TC1775

TC1775 Documentation Addendum

Revision History: **2003-02**

This document describes corrections, changes, and improvements for the two parts of the TC1775 User’s Manual V2.0 2001-02, the System Units book and the Peripheral Units book. These corrections will be considered with the next update of these User’s Manual documents.

DMU_CON

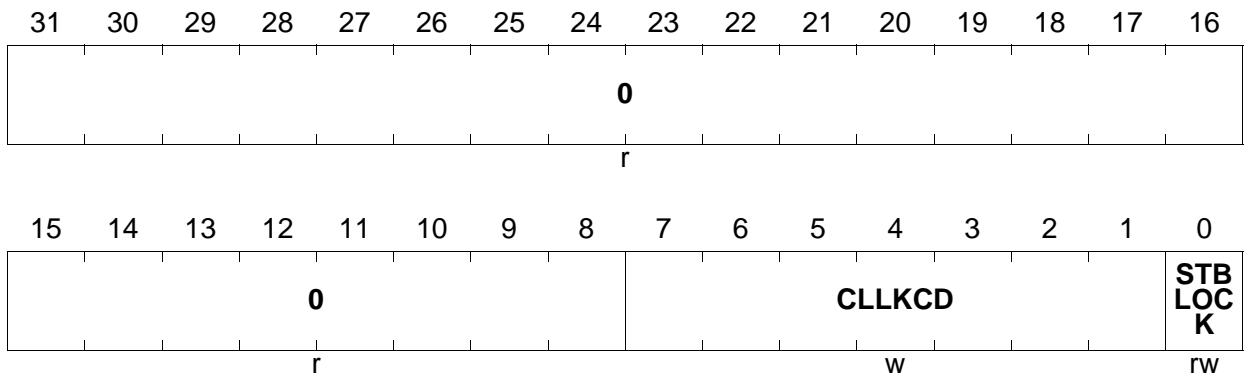
Page 9-11

The description of register DMU_CON must be corrected in the following way:

Field	Bits	Type	Description
STBLOCK ¹⁾	0	rw	Lock Standby Data Memory Bit can be set by writing a 1 to it (in supervisor mode only). Bit can only be reset (in supervisor mode only) by writing a 0 to it together with the appropriate clear lock code. 0 Normal operation of standby data memory 1 Standby data memory is locked. No read or write access of/to standby SRAM is possible. The state of STBLOCK after power-on reset is undefined. A hardware or software reset does not effect this bit.
CLKCD	[7:1]	w	Clear Lock Code This bit field has to be written with 65 _H together with STBLOCK = 0 to reset the lock of the standby RAM.
0	[31:8]	r	Reserved ; read as 0; should be written with 0.

Figure 10-2 Example Configuration of a Data Protection Register Set

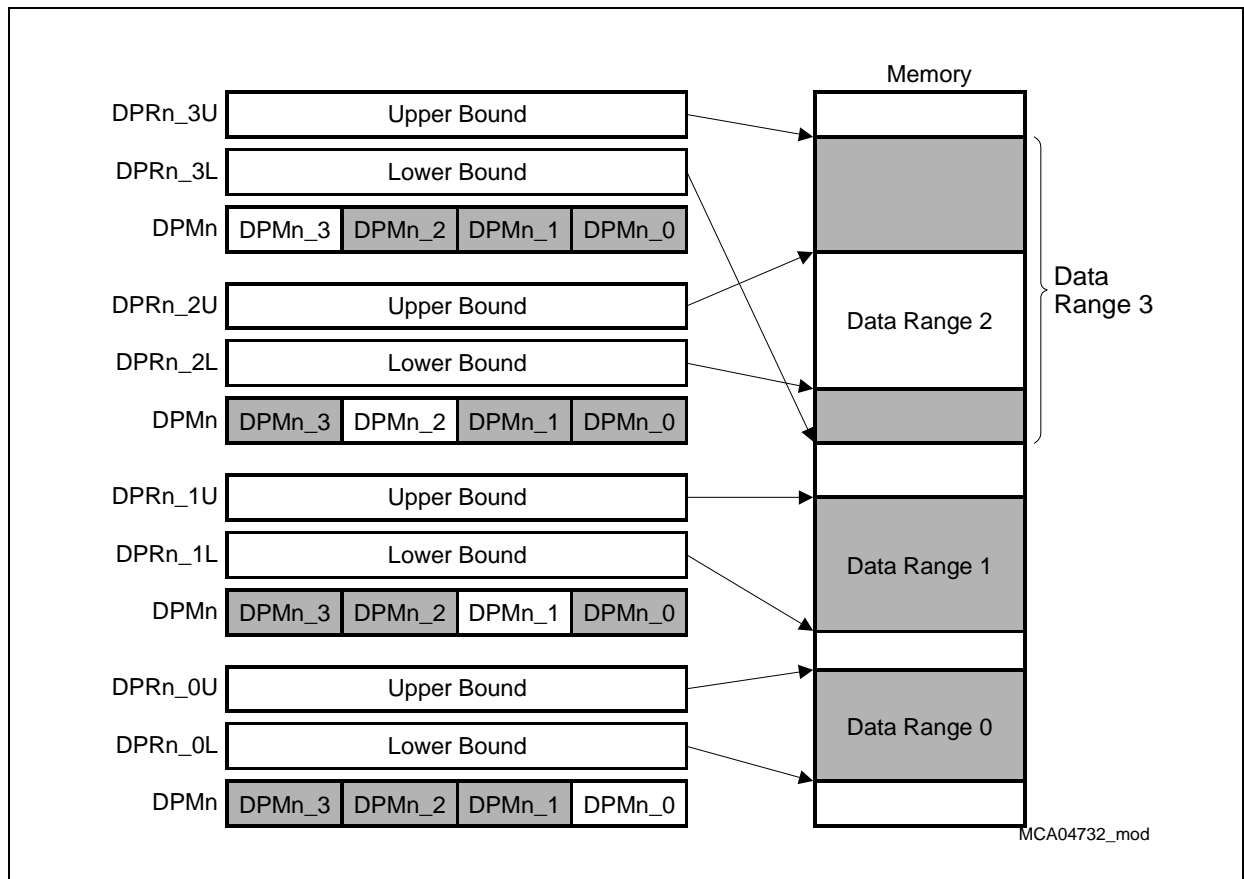
The Data Range numbering in **Figure 10-2** is not correct. The figure must be updated in the following way:

Figure 12-6 Basic Read Access Timing in Demultiplexed Mode

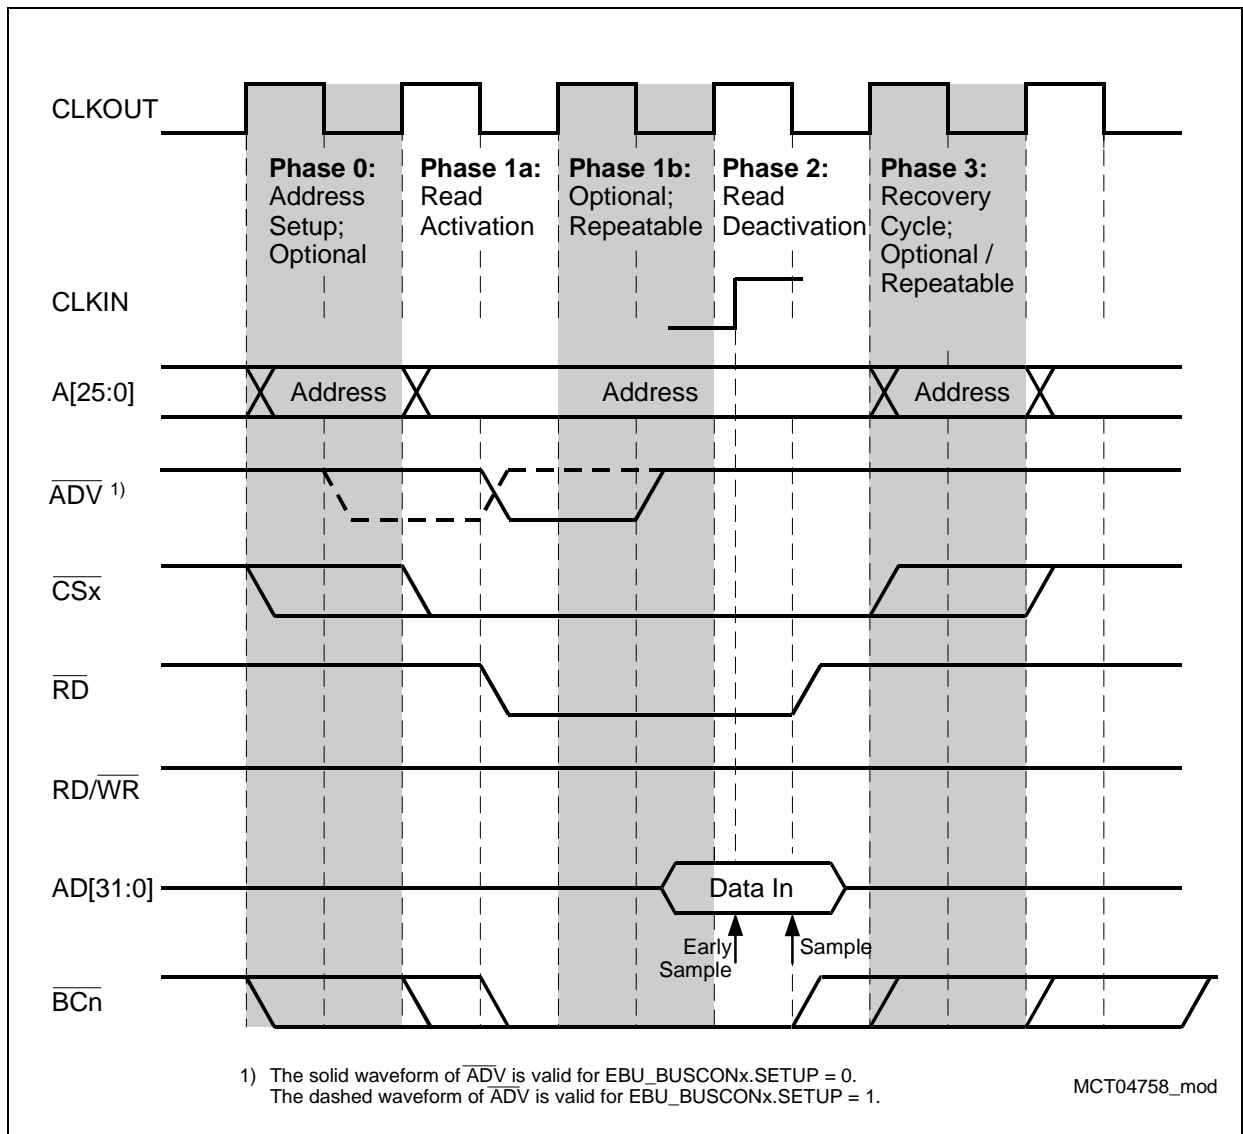
The TC1775 provides an additional demultiplexed read timing feature called “Early Sample”. This feature is shown in the corrected **Figure 12-6** and controlled via bit 26 (called ES for “Early Read Sample Select”) in register EBU_BUSCONx. EBU_BUSCONx.ES must be added as described on **Page 12**).

Figure 12-6 and **Figure 12-7** are also corrected concerning signal \overline{ADV} . As shown in these two figures, the \overline{ADV} timing depends on the setting of bit $EBU_BUSCONx.SETUP$.

- “Phase 2: This cycle is always part of a read access. Please note that the read signal is deactivated (high) on the falling edge of CLKOUT. The data input is sampled and latched with this clock edge ($EBU_BUSCONx.ES = 0$) or with the rising edge of CLKIN when early sample is enabled with $EBU_BUSCONx.ES = 1$.”

Figure 12-16 EBU Boot Process after Reset

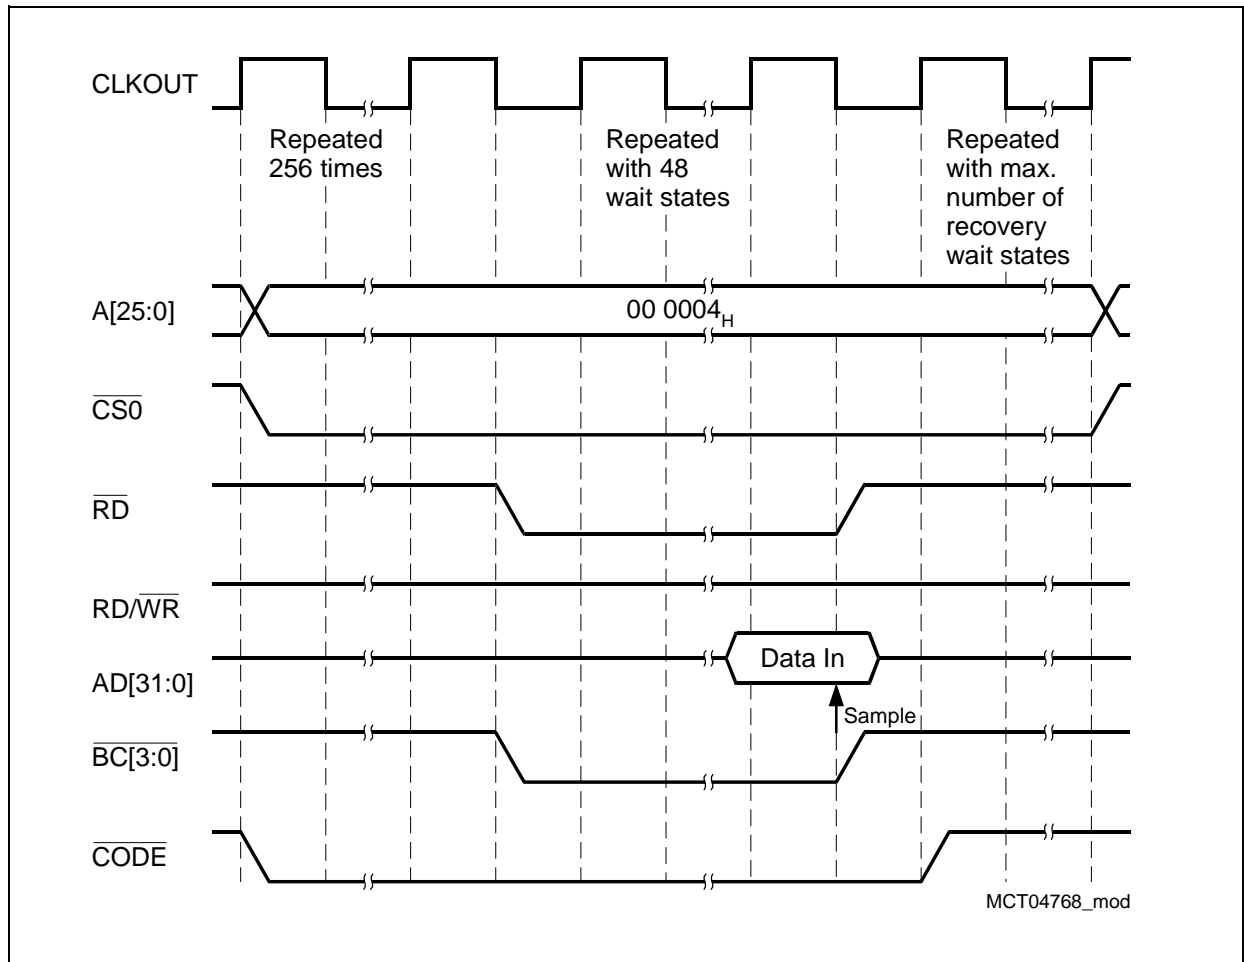
Page 12-44, Update of Figure 12-16

Figure 12-16 should be update with the following drawing:

Figure 31 Approximated Maximum Accumulated PLL Jitter for Typical System Clock Frequencies f_{SYS}

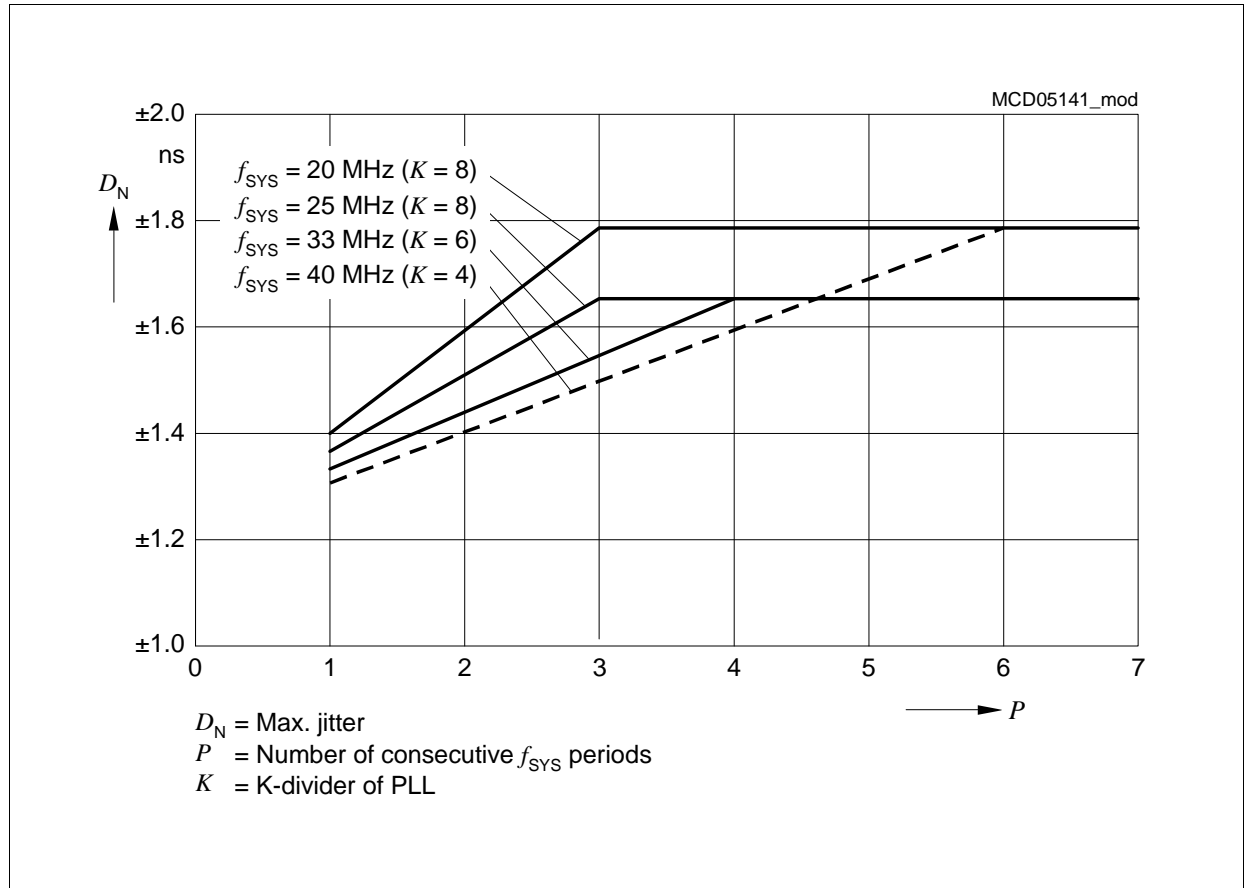
Caused by the correction of Figure 31 on page 83, the last paragraph must be updated as follows: “Figure 31 gives an example for typical jitter curves with $K = 4$ @40 MHz, $K = 6$ @33 MHz, and $K = 8$ @20/25 MHz.”

Figure 31 must be corrected as shown below.
